Regulation No. 118 (Burning behaviour of materials)

Proposal for amendments to Regulation No. 118 (Burning behaviour of materials)

Submitted by the experts from France, Germany, Norway and Sweden*

Example 1

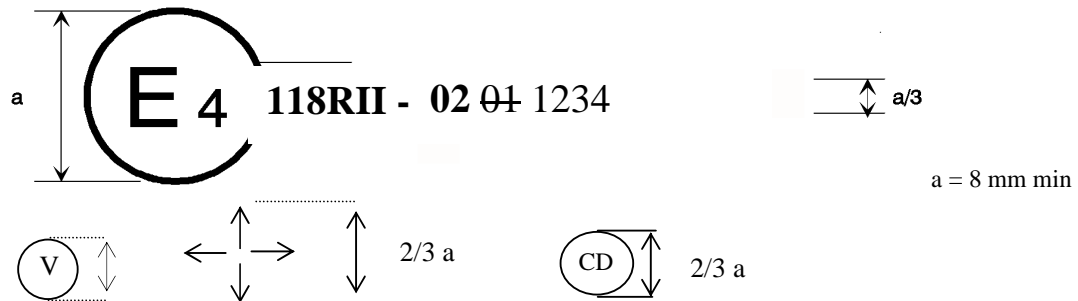
Annex 5, amend to read:

The above approval mark affixed to a vehicle shows that the type concerned was approved in the Netherlands (E4) pursuant to Part I of Regulation No. 118 under approval No. 01 021234. The first two digits (01 02) of the approval number indicate that the approval was granted in accordance with the requirements of the 01 02 series of amendments to Regulation No. 118.

To update the approval mark from 01 series to 02 series of amendments. The wording for symbols shall be consistent with the proposed requirements. The symbol "CD" is corrected.

Figure 1
Specimen holder (Dimensions in millimetres)

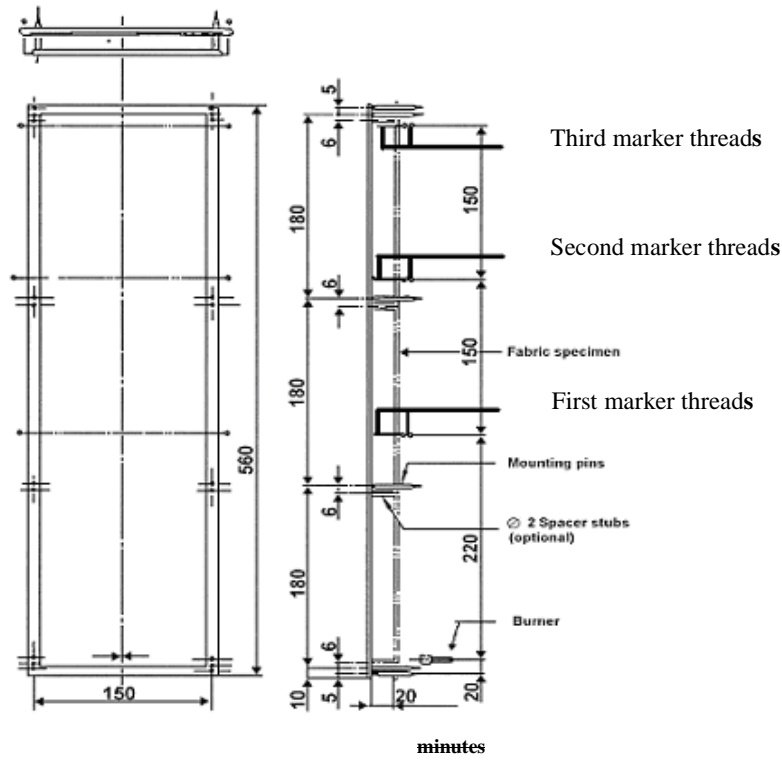
4.4. The marker threads shall be attached horizontally in front **of and behind** of the specimen at the locations shown in figure 1. At each location, a loop of thread shall be mounted so that the two segments are spaced 1 mm and 5 mm from the **front and rearface** ~~plane of the front~~ of the specimen.

Annex 8, figure 1, amend to read:

The figure is updated to show the location of the marker threads. Correction of the figure by deleting the word "minutes".

Figure 2
Burner ignition location (Dimensions in millimetres)

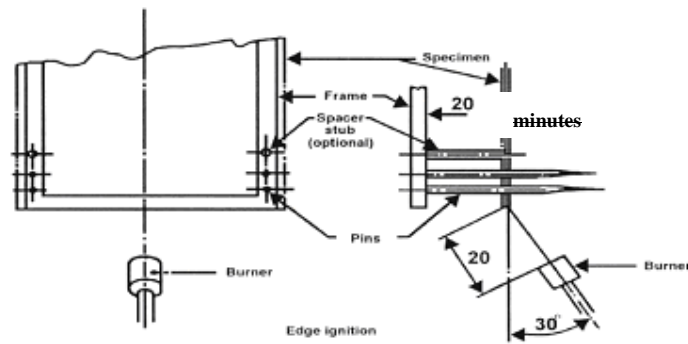
Annex 8, figure 2, amend to read:

Correction of the figure. The wording "Dimension in millimetre" which is missing in the current text of Regulation is added. Deletion of the word "minutes".
